Recommended Contracting Actions Summary

Date: November 10, 2016

Technical Advisory Group Recommendation

Meeting Date: 10/19/2016

10/20/16 03:23:19PM H:\Fargo\JBN\7400\7438\12_7438_009\006-In-Townr_Levees Phase 1\CAD\2nd St N\WP42F.1.N\95% Plans\020_LANDSCAPE_DETAIL - C0#2.dwg

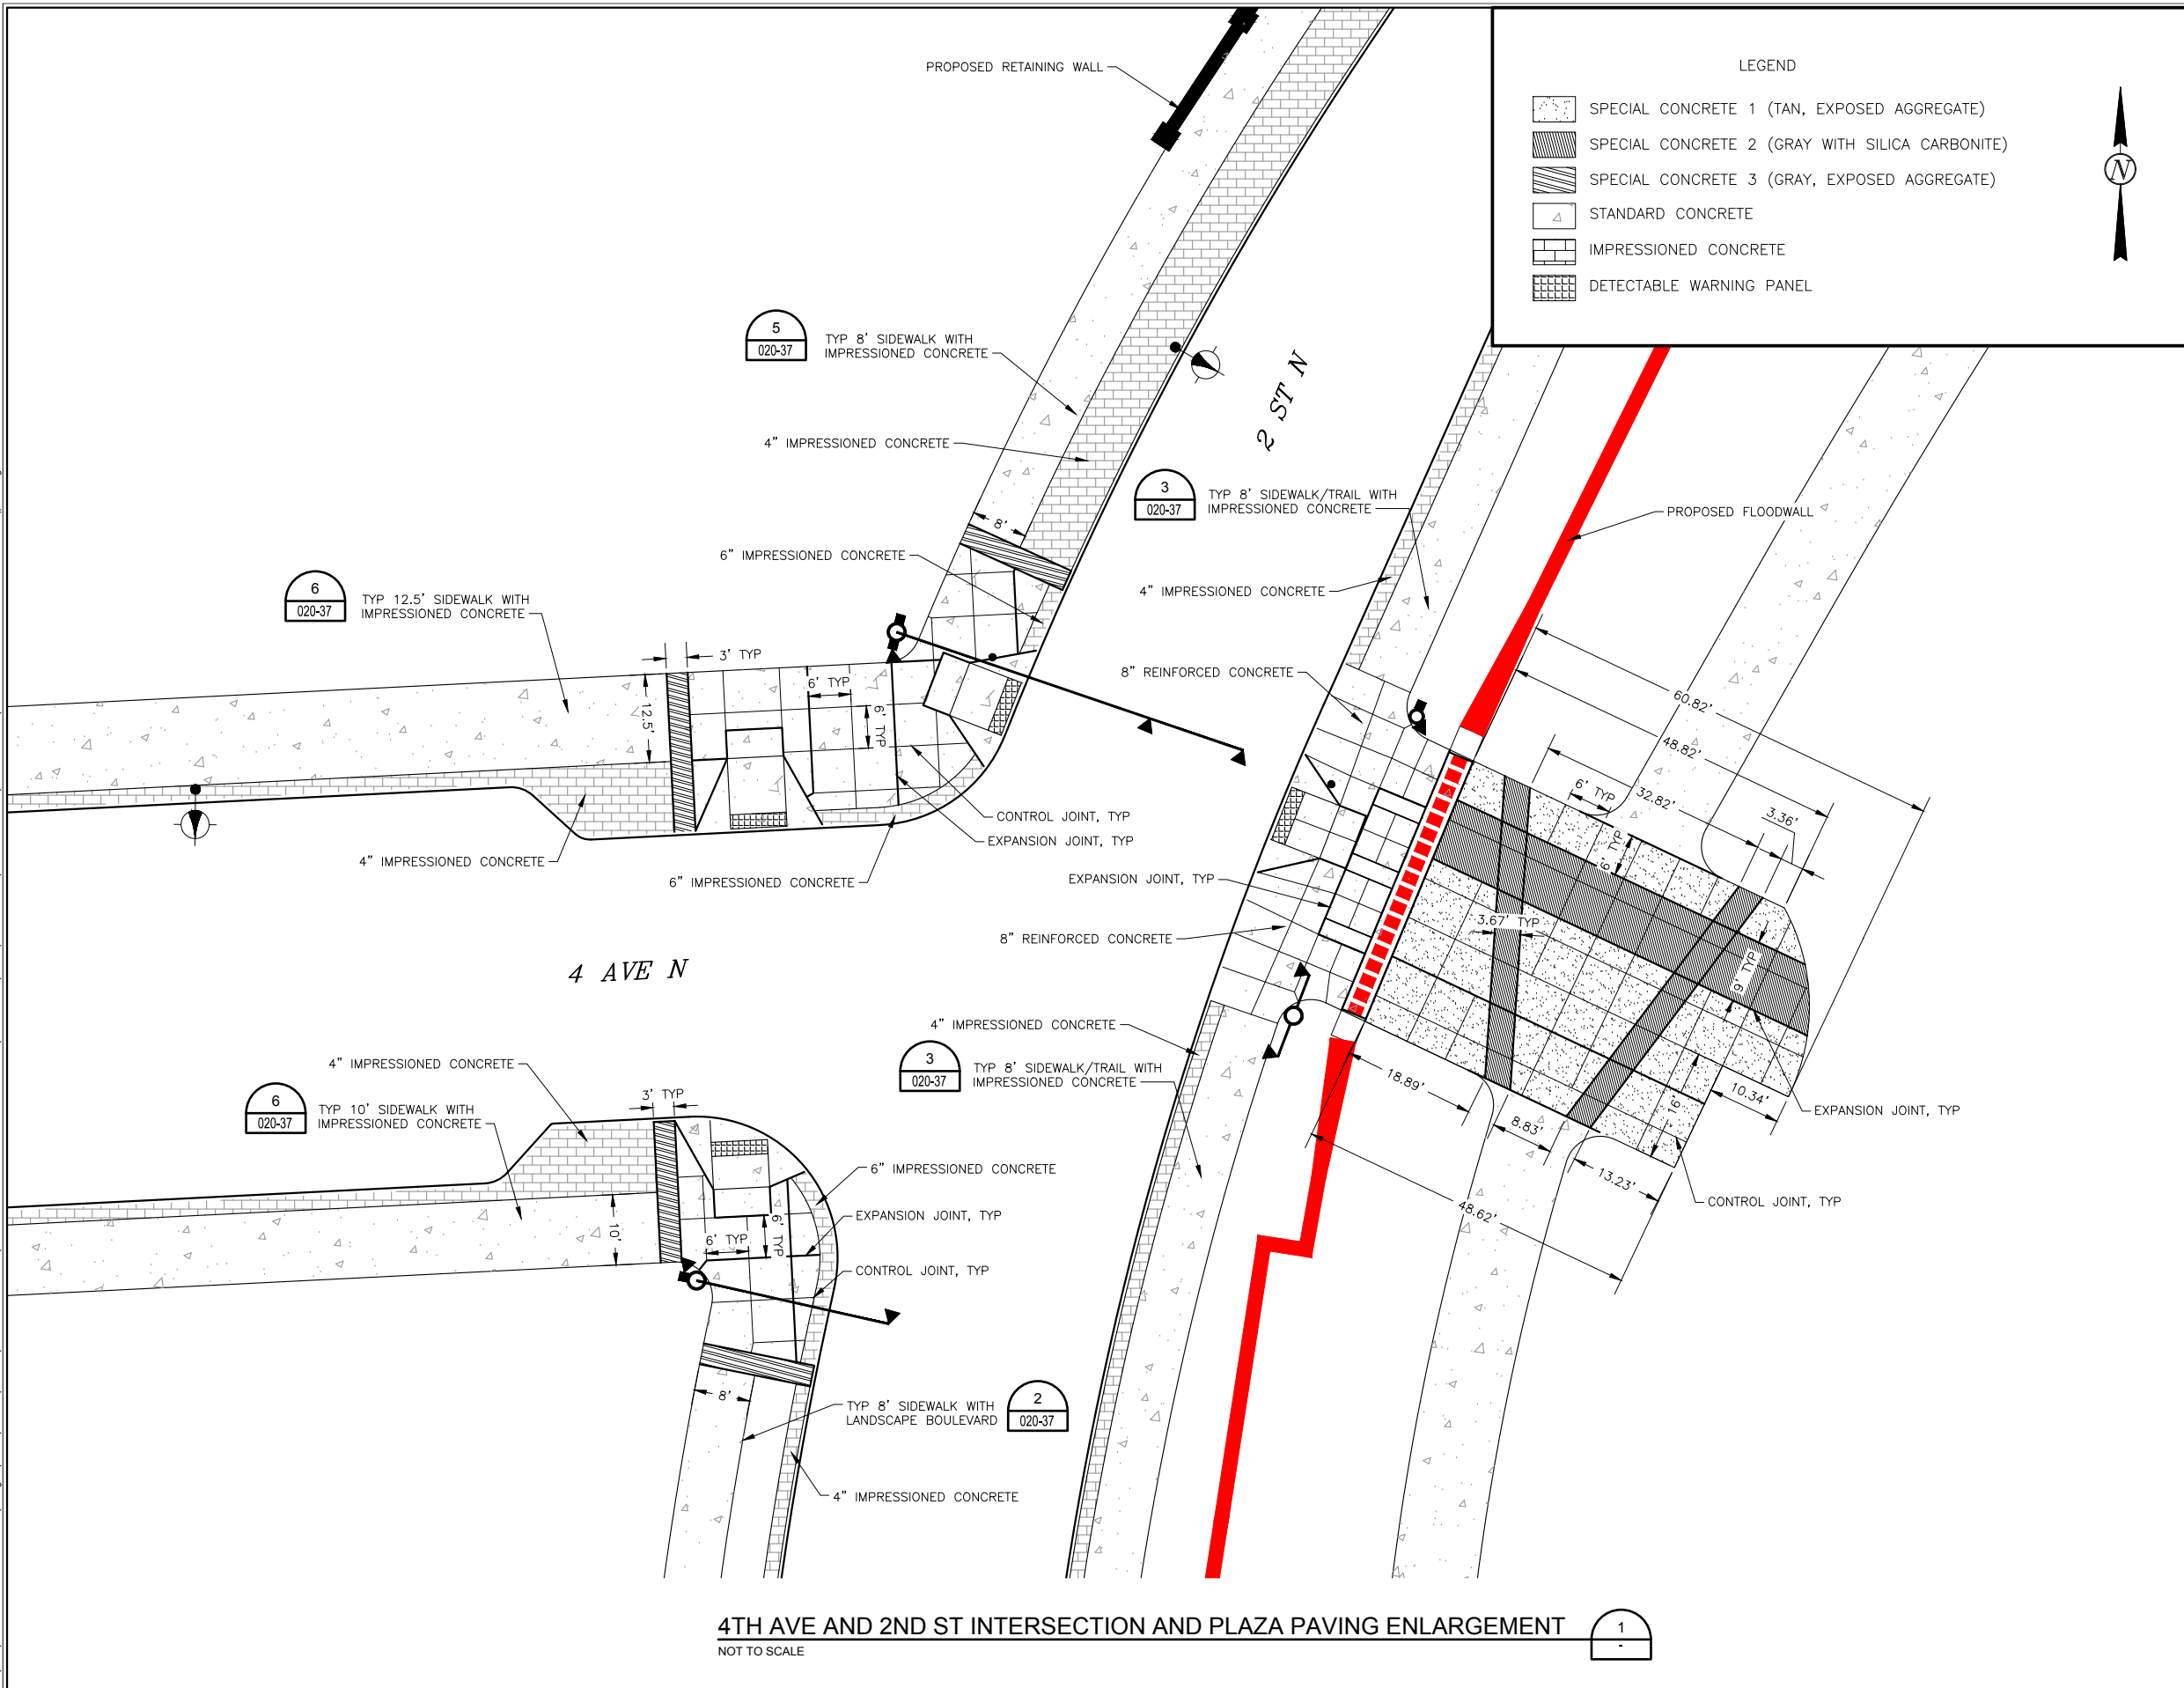
6.a.10 WP-42F.1N Flood Control - 2nd St. N. (North of Pump Station) – Change Order 04 <ul style="list-style-type: none"> • 8” Plaza Concrete • Pull Boxes • Temporary Straw Mulch • Milestone Changes 	Industrial Builders, Inc.	9,158.00
Total Construction Change Orders		62,794.42
